Item ID: D212-664-101TRN

Item Name: Crosstube Turning Detail

| DRAWING NO. D212-664-141 | TITLE XTUBE ASSY (205/212/412 HI FWD) | REV. D | DART AEROSPACE LTD ENGINEERING ORDER | | D.E.O. NO. D212-664-141-D-1 | SHEET NO. SHEET 1 OF 2 | SCALE NTS |

ADD AN INSPECTION WINDOW TO UNDERSIDE OF CROSSTUBE.

**D212-664-141/-141B
ASSEMBLY DETAIL**

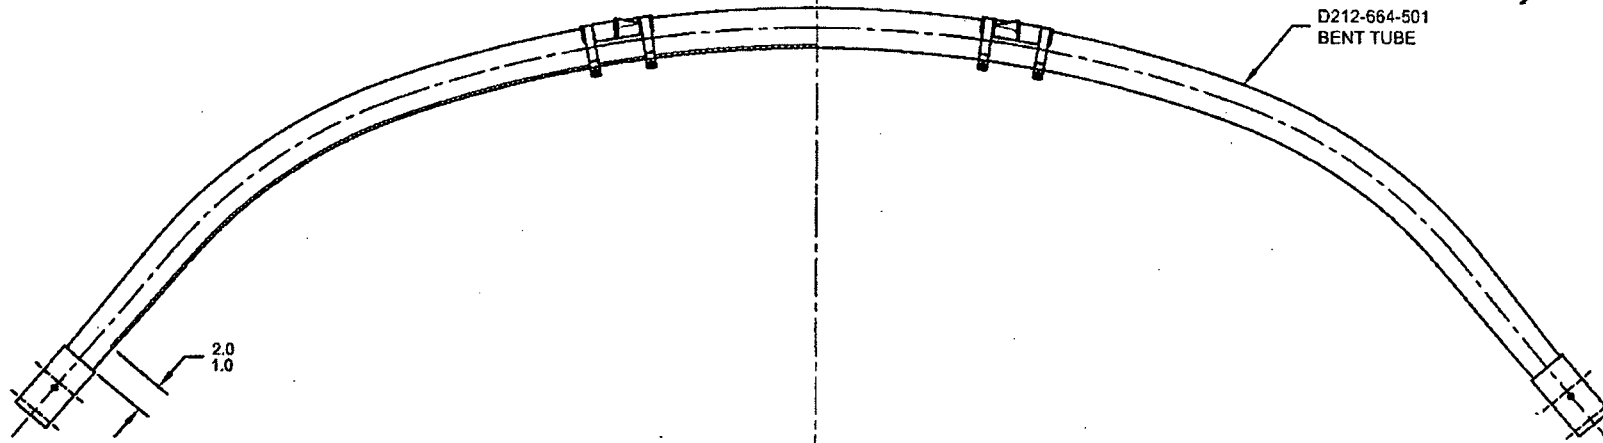
NOTES 2 OF SHEET 1 IS AMENDED AS FOLLOWS:

- 2) FINISH: CHEMICAL CONVERSION COAT PER DART QSI 005 4.1
PRIME INSIDE AND OUTSIDE PER DART QSI 005 4.2
MASK UNDERSIDE OF CROSSTUBE AS SHOWN (HATCHED AREA) AND
PAINT OUTSIDE PER DART QSI 005 4.2
REMOVE MASKING AND APPLY CLEAR COAT

- 2) FINISH: CHEMICAL CONVERSION COAT PER DART QSI 005 4.1
PRIME INSIDE AND OUTSIDE PER DART QSI 005 4.2
PAINT OUTSIDE PER DART QSI 005 4.2

MASK AREA PRIOR TO PAINTING,
REMOVE MASKING AFTER PAINT
AND APPLY CLEAR COAT
